M2PP-121-D-PLNM-0008

Site Specific Management Plan 008 - [sectors 480/510]
MacKays to Peka Peka Expressway

31 MARCH 2015 - REV C - CERTIFIED ISSUE

SITE SPECIFIC MANAGEMENT PLAN - TE MOANA [SSMP 8 - SECTOR 480, 510]

Title: SSMP 8 [480-510] - SHEET 14 LIGHTING LOCATION PLAN

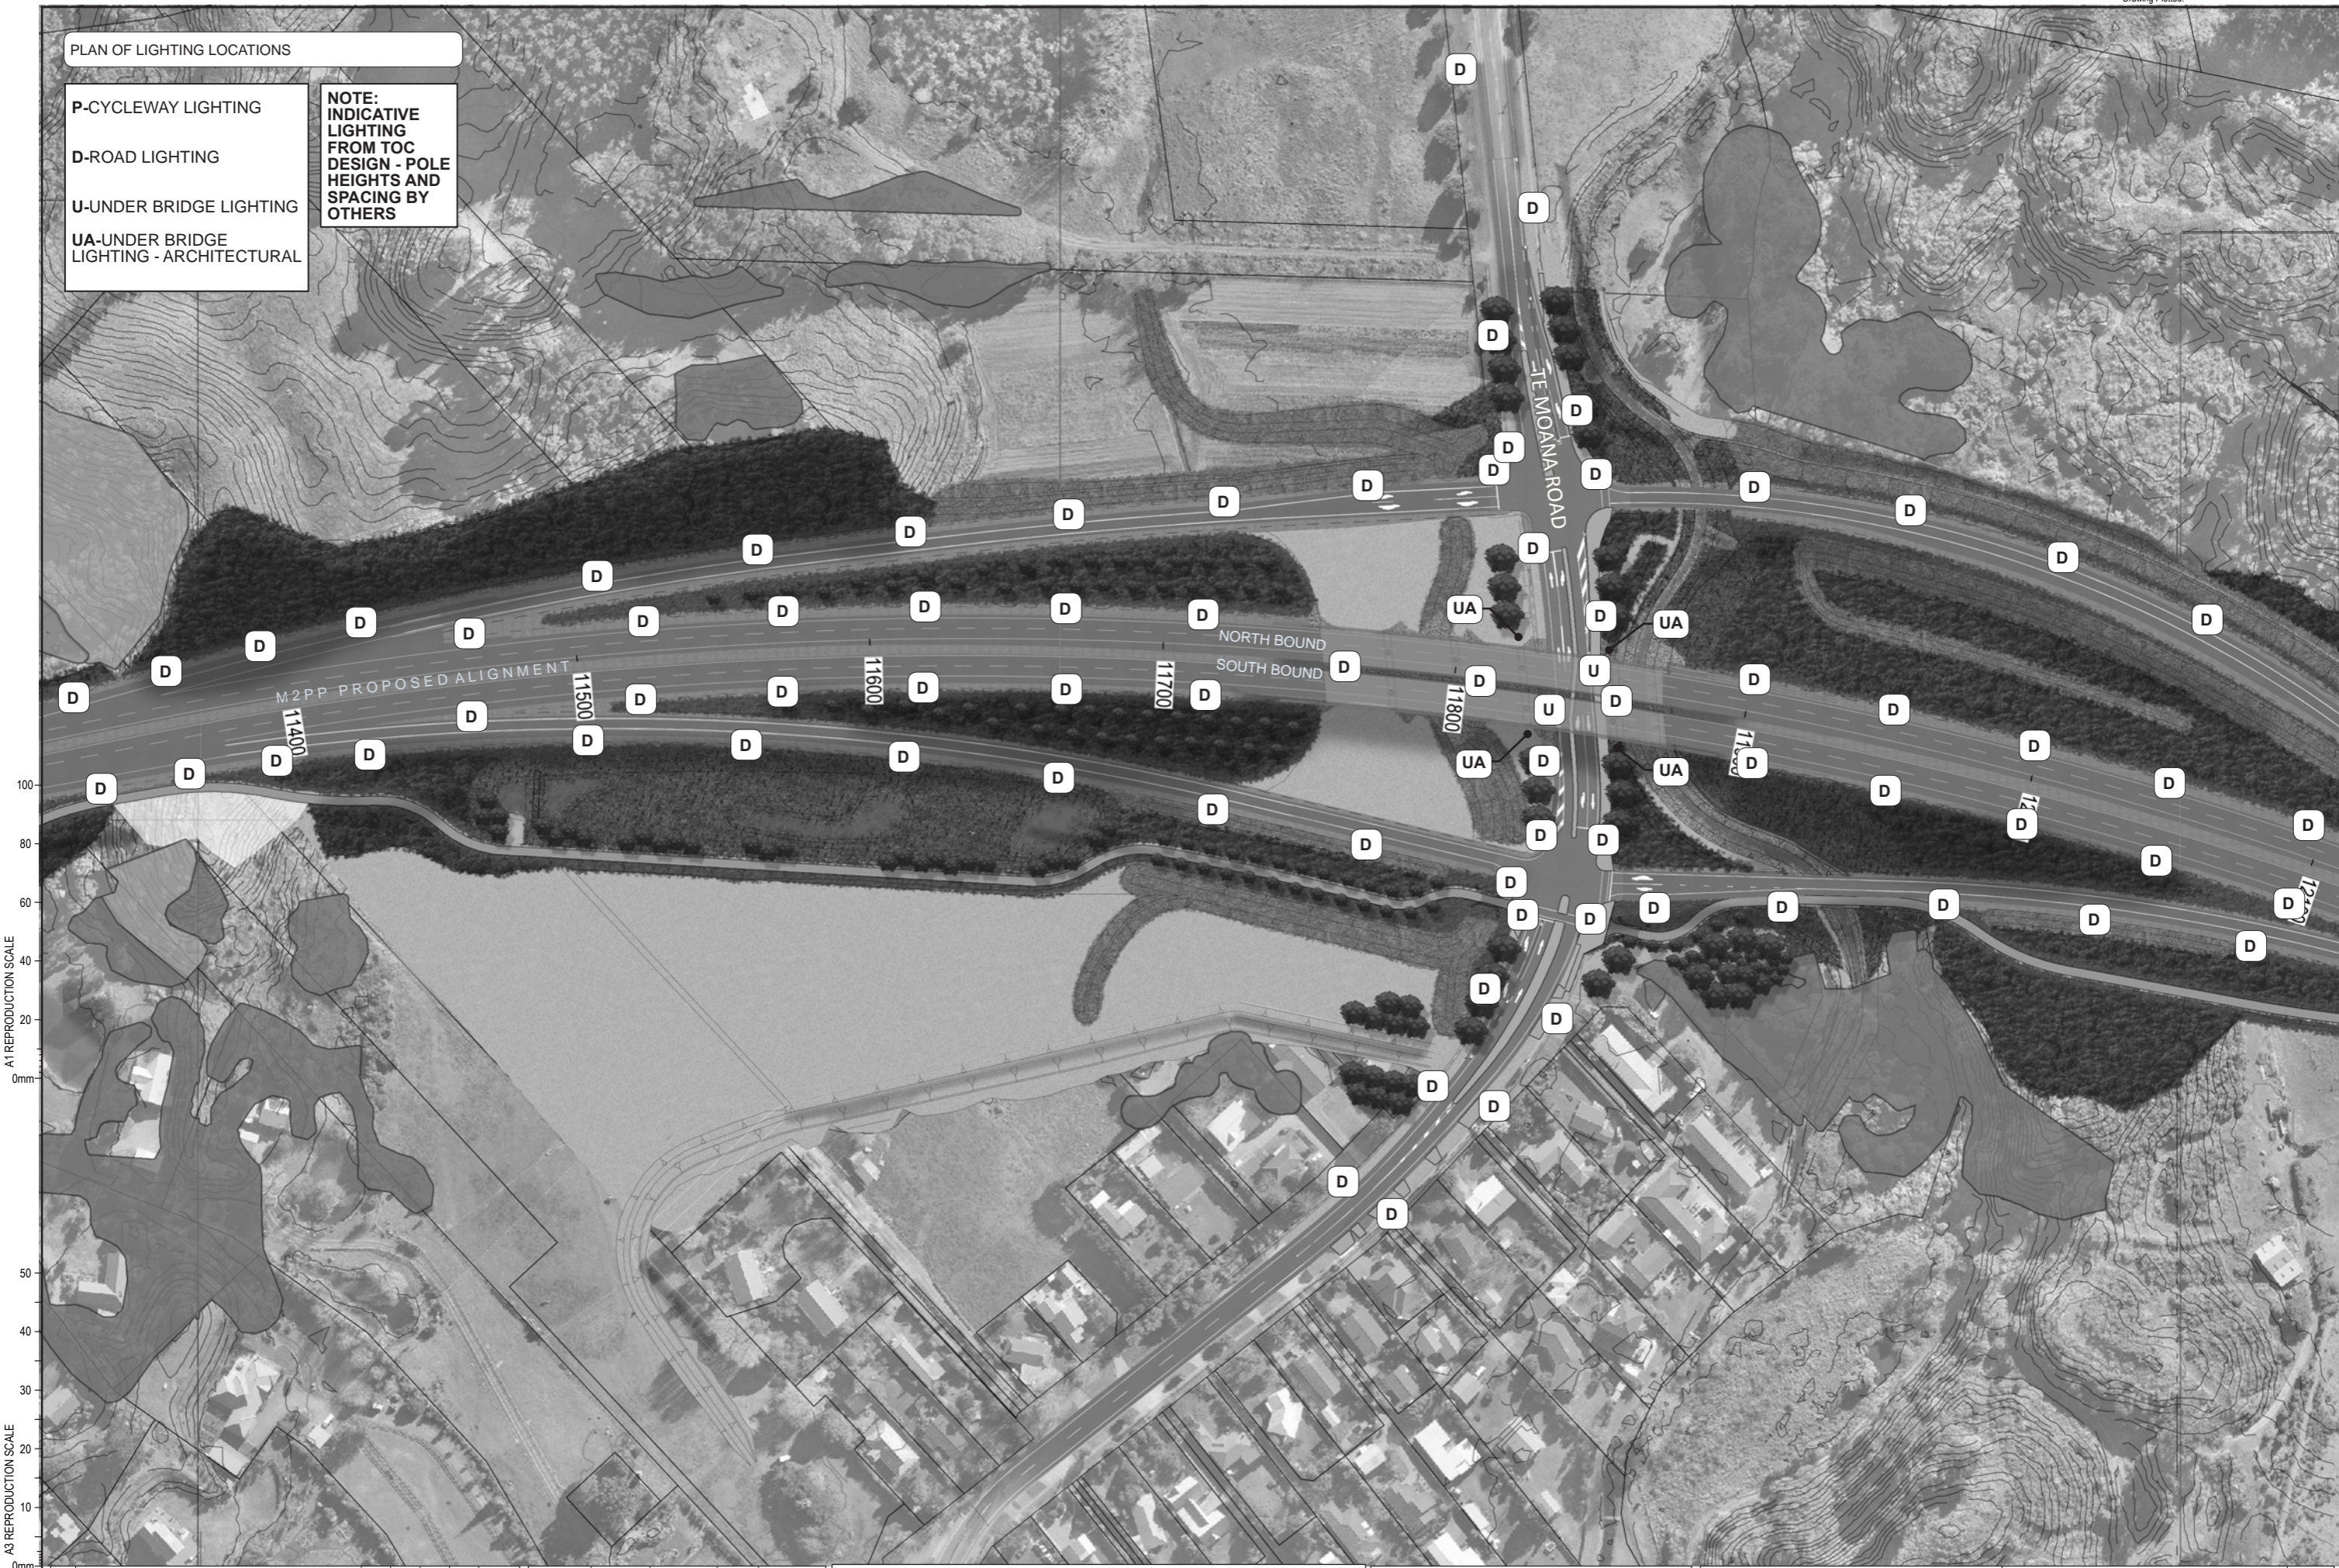
Lighting required at CWB exit onto Kauri Road.	Sheet 14	As above. Refer SSMP7
		<p>Is lighting required at CWB exits onto Te Moana Road or will standard street lighting be enough?</p> <p>No uplighting under bridge. Is this consistent with Appendix 3: Bridge summary ULDF Principle 6?. This is one of the most used urban routes in terms of local pedestrian and cycle use. The ULDF discussed techniques for 'lightening the space' under bridges. (See below). We are not suggesting that the piers should be painted but the large areas of riprap and new road configuration could turn this underbridge area into a rather bleak environment.</p> <p>We need more information on the local user experience within the underbridge landscape and expect to see specific mitigation options shown to create a positive environment for local pedestrian and cycle movement.</p> <p>Refer ULDF principles 4 & 13 in <i>Appendix 3 Bridge Summary</i>.</p>	Sheet 15	<p>The proposed Te Moana road street lighting provides enough light at the CWB intersection.</p> <p>Architectural lighting will be used to add additional interest and safety at night.</p> <p>Softly up light the 4 columns (the two either side of Te Moana Road) to accentuate the form of the columns.</p> <p>The bridge development study text will be updated to match this discription</p> <p>As with Poplar, Wharemauku Kapiti, Waikanae Bridge we are working with Te Ati Awa to realise their aspiration to have Te Ati Awa specific designs incorporated into the column finish. An example of the Te Ati Awa design concept for the Waikanae bridge has been included into the SSMP 8. We are proposing a similar approach for the Te Moana overpass bridge columns. The consultation on this design element is ongoing. The Te Ati Awa motif design may differ for Te Moana.</p> <p>The pedestrian experience under Te Moana Bridge will be more inviting than most other bridges on the expressway. The length of the bridge and the fact that the bridge abutments are separated from the road/pedestrian corridor (Pedestrian corridor consists of 3m shared path, separated from the live lane by a 1.5m on road cycle lane/shoulder) and the fact the ground falls away on both sides of Te Moana road (Refer Cross section CS5) will make Te Moana Road feel more open than most other bridges</p> <p>The orientation of the bridge in relation to the sun (north) will let plenty of natural light under the bridge between midday and late afternoon. The change to a split bridge will also let more natural light to the underside of the bridge</p>

Title:	SSMP 8 [480-510] SHEET 22 TE ATIAWA COLUMN DESIGN
--------	---

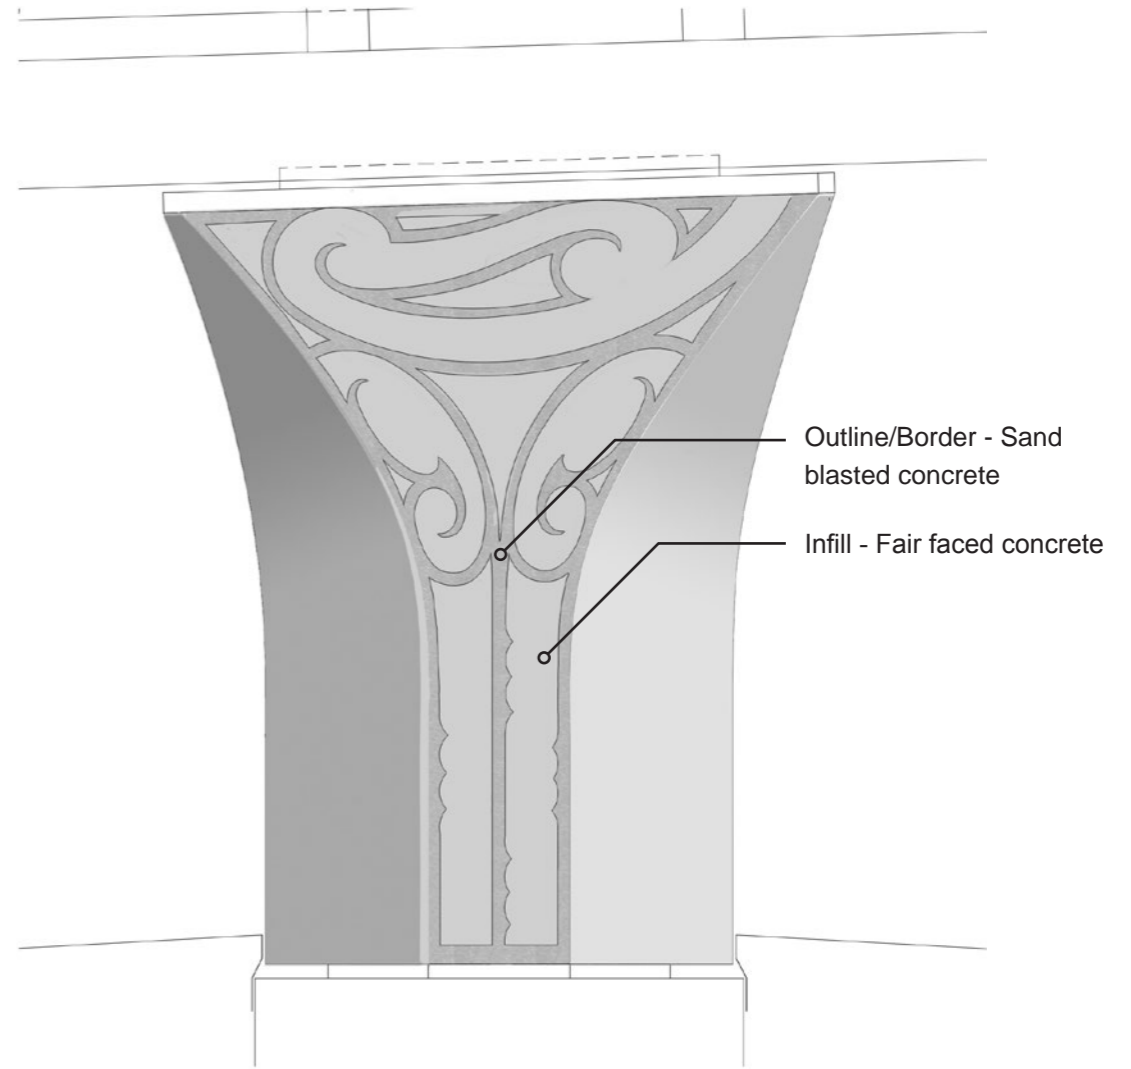
2.1 POST CERTIFICATION CHANGES							
DRAWING/PAGE TITLE:	DRAWING NUMBER:	DRAWINGS STATUS:	REVISION NO:	DESCRIPTION OF CHANGE:	ISSUED TO:	CERTIFIED BY:	DATE:
SSMP 8 [480-510] - SHEET 2 Master Plan	M2PP-121-D-DWG-8101	Revision/Update	D	Retaining wall- update reference note. Retaining wall details to be found in Retaining wall addendum to SSMP 8	KCDC		3.5.16
SSMP 8 [480-510] - SHEET 3 Master Plan	M2PP-121-D-DWG-8102	Revision/Update	D	Retaining wall- update reference note. Retaining wall details to be found in Retaining wall addendum to SSMP 8	KCDC		3.5.16
SSMP 8 [480-510] - SHEET 11 Puriri Road CWB Detail	M2PP-121-D-DWG-8801	Revision/Update	D	Revised CWB interface with Puriri Road.	KCDC		3.5.16
SSMP 8 [480-510] - SHEET 21 Type 1 CWB entrance	M2PP-121-D-DWG-8803	New Sheet added	A	CWB entrance structures Type 1 - design change to precast units. To replace 'gabions' on sheet 12	KCDC		3.5.16
SSMP 8 [480-510] - SHEET 22 Te Atiawa Column Design	M2PP-121-D-DWG-8804	New Sheet added	A	Page added to illustrate Te Atiawa design to be applied to bridge columns (sand blasted etching)	KCDC		3.5.16

Title: TE MOANA RD INTERCHANGE VEGETATION TO BE RETAINED
 SHEET 2

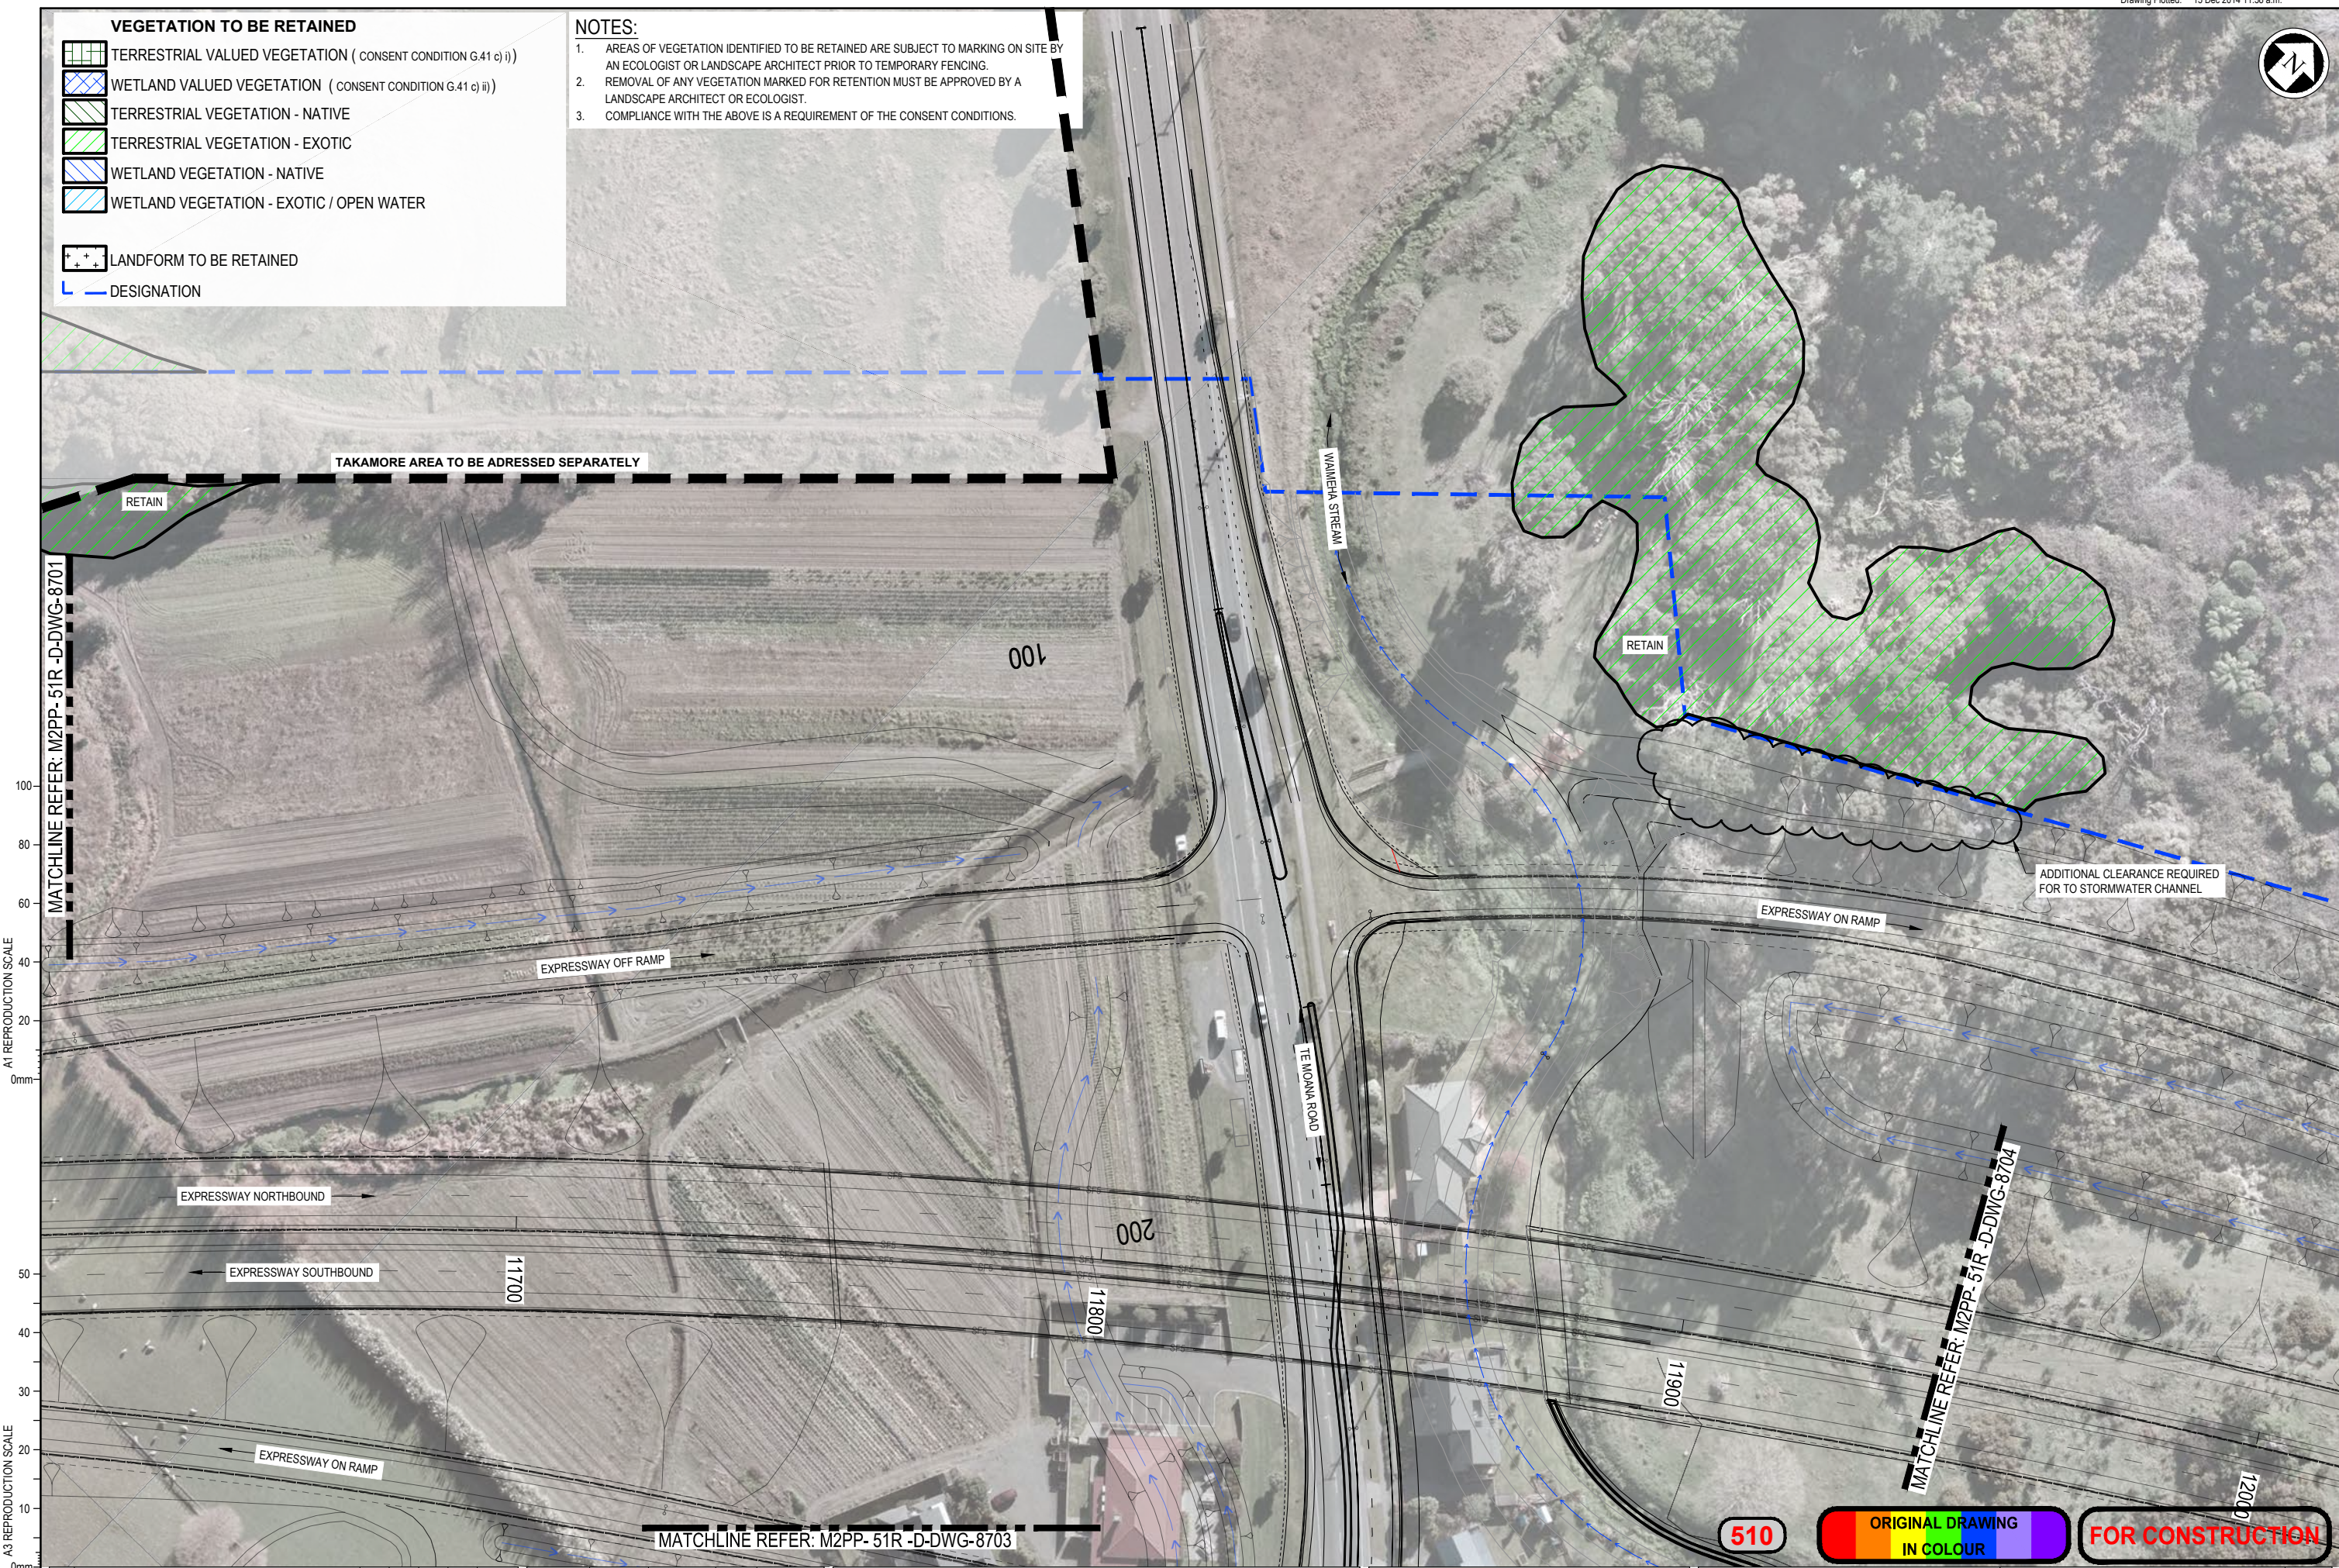
<p>5. On the vegetation sheets (Vegetation to be retained sheet 2) we note that most of the vegetation on ex Tocker's land is to be retained but not all, and we are not clear whether that is on oversight, simply that individual trees are too small to be identified or what. We are particularly interested in the trees by the side of the drive along the edge of their and our property where we would hope as much of the vegetation as possible could be preserved. It may be that this is not indicated as being preserved because this is the area in which the drain out into Puriri Road will go but as that seems not to be identified, it is hard to know.</p> <p>6. We note too that on the plan most of the vegetation on our property is identified as being preserved but this fails to include the planting by the drive.</p> <p>7. We note that on Vegetation to be Retained Sheet 1 a large area is designated as "retain duneform". No such designation appears on Sheet 2 for the ex Tocker property but we presume that it is the intention to preserve the present land forms?</p>
